SERVICE INSTRUCTION

DATE: December 9, 2005 Service Instruction No. 1438A
(Supersedes Service Instruction No. 1438)

SUBJECT: Propeller Governor Pad Plate P/N LW-12347

MODELS AFFECTED: All four and six cylinder, dual magneto engines with rear mounted propeller governor drives.

Propeller Governor Pad Plate and Gaskets

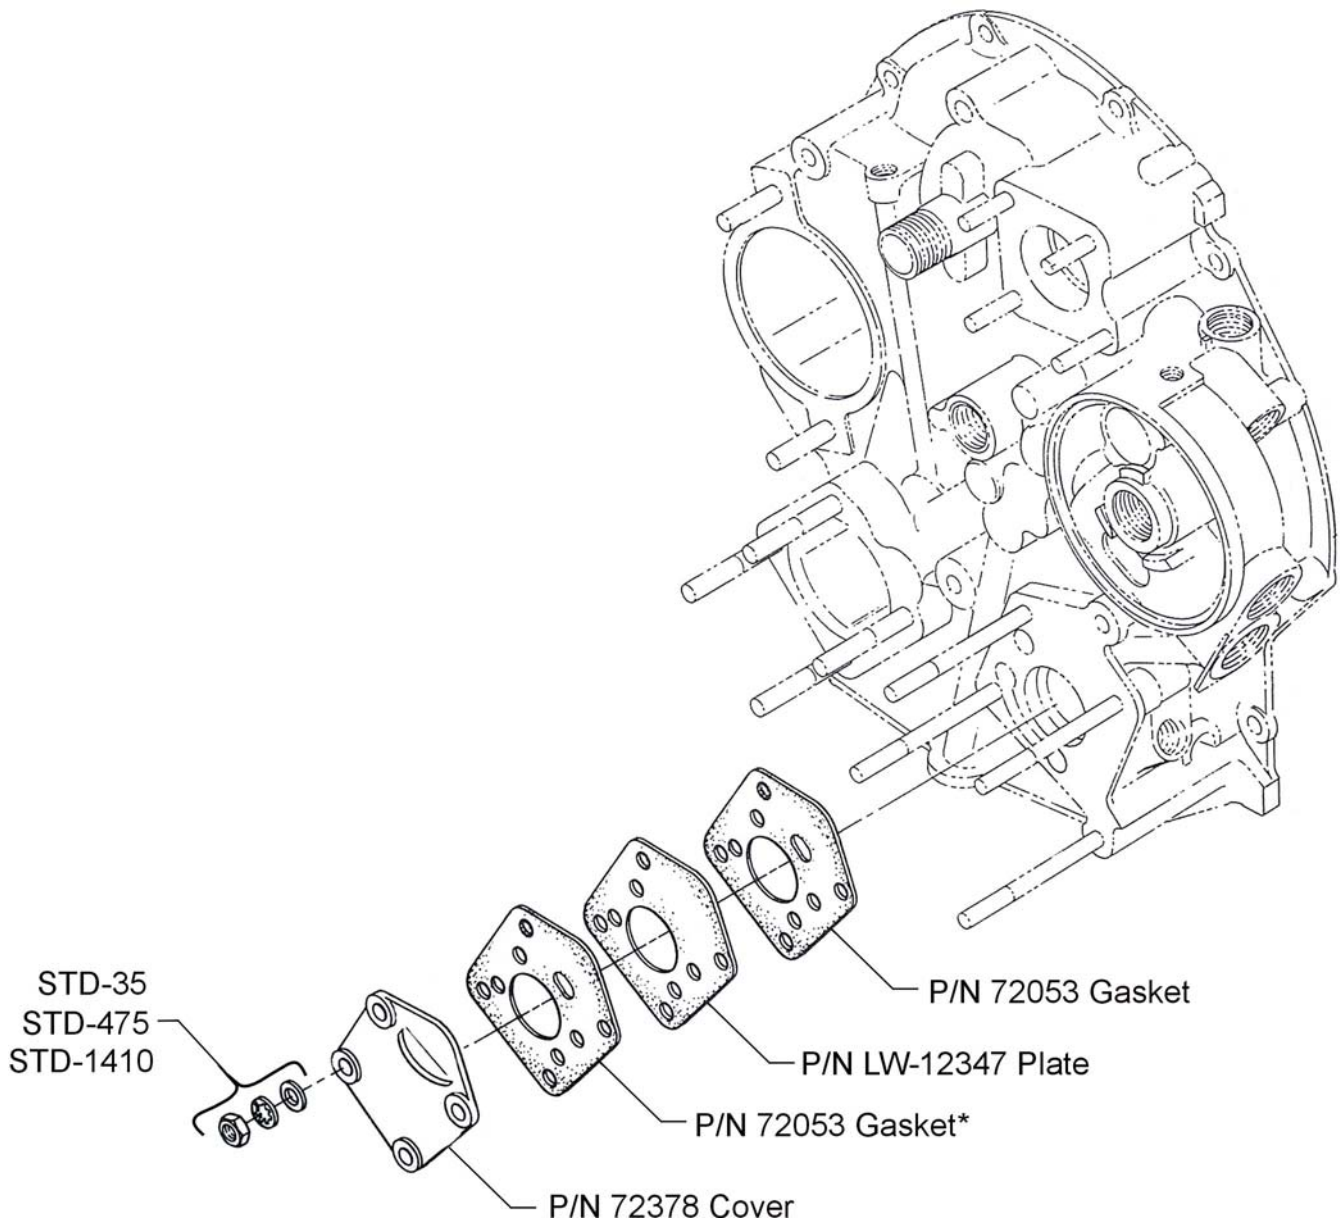
The use of a P/N LW-12347 propeller governor pad plate and two P/N 72053 gaskets on dual magneto engines with rear mounted propeller governor drives is necessary with some propeller governors to eliminate the possibility of oil leakage between the propeller governor and the accessory housing.

As a product improvement, to insure against oil leakage, the propeller governor pad plate and gaskets are being incorporated and will not effect operation with any propeller governor drive installed on the engines. See illustration.

WHEN INSTALLING THE PROPELLER GOVERNOR, THE P/N 72053 GASKET BETWEEN THE PROPELLER GOVERNOR PLATE AND THE COVER IS REPLACED BY A GASKET SPECIFIED BY THE AIRFRAME OR PROPELLER GOVERNOR MANUFACTURER. (REFER TO AIRFRAME IPC.) LYCOMING DOES NOT SUPPLY THIS GASKET; HOWEVER, IT MAY BE PURCHASED THROUGH THE AIRFRAME OR PROPELLER GOVERNOR MANUFACTURER.

* Replaced by gasket specified by airframe or propeller governor manufacturer when propeller governor installed.
